SERVICE BULLETIN

Fuji Heavy Industries, Ltd.

NO. FAS-023A

1. SUBJECT Replacement of rod interlocked brake pedals.
2. AIRCRAFT AFFECTED : FA-200 Serial Nos. 12 through 101.
3. PRIORITY : Desirable.
4. REASON :  
Worn rudder pedal hinge portion at the connection area of the rudder pedal and interlocking rod were found out.  
Replace the master cylinder connecting rod with the revised ones to prevent possible wearing.
5. DESCRIPTION : Replace the rod interlocked brake pedals with new improved parts.
6. ACCOMPLISHMENT : At first 500 hours or 1000 hours check after receiving this Service Bulletin.
7. APPROVAL : Not applicable.
8. PARTS REQUIRED : The following parts will be submitted to the owners without fee.

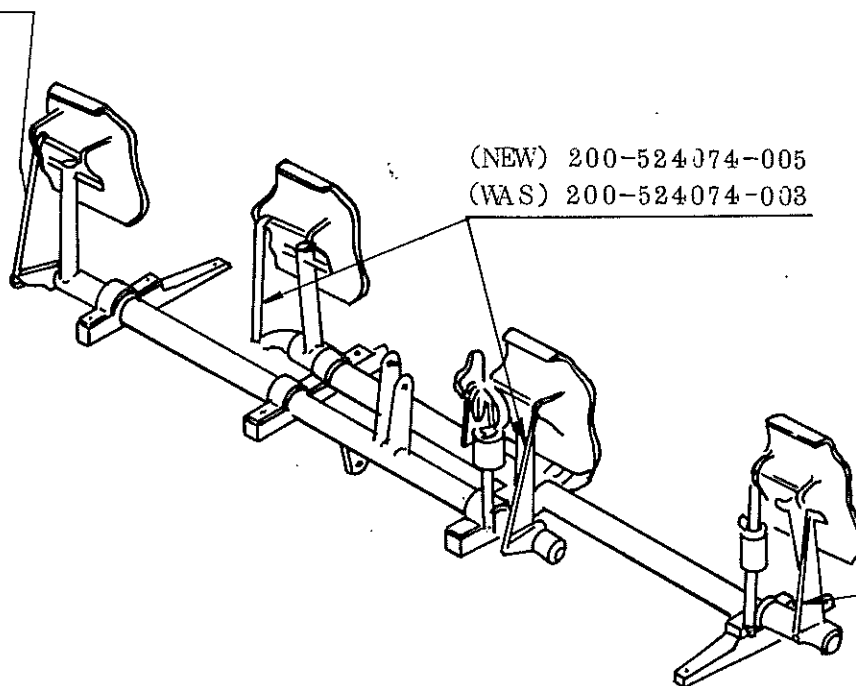
9. SPECIAL TOOLS : None required.
10. WEIGHT AND BALANCE : Negligible.
11. REFERENCE : Nothing.
12. MANPOWER : 1 MH.
13. WORK PROCEDURE :
- 13-1. Remove 4 rod interlocked brake pedals from the rudder pedals and torque tube arm portion.
- 13-2. Remove 4 rudder pedals and make the smooth surface for the worn out rudder pedal edge bracket and wipe them clean cloth which contains Arozin Solution.
- 13-3. Install the rudder pedals and new improved interlocking rod. Operate the rudder and brake after installing and make sure that the rudder and brake operations will be carried out sufficiently.

(NEW) 200-524079-006

(WAS) 200-524079-004

(NEW) 200-524074-005

(WAS) 200-524074-003

(NEW) 200-524079-006

(WAS) 200-524079-004
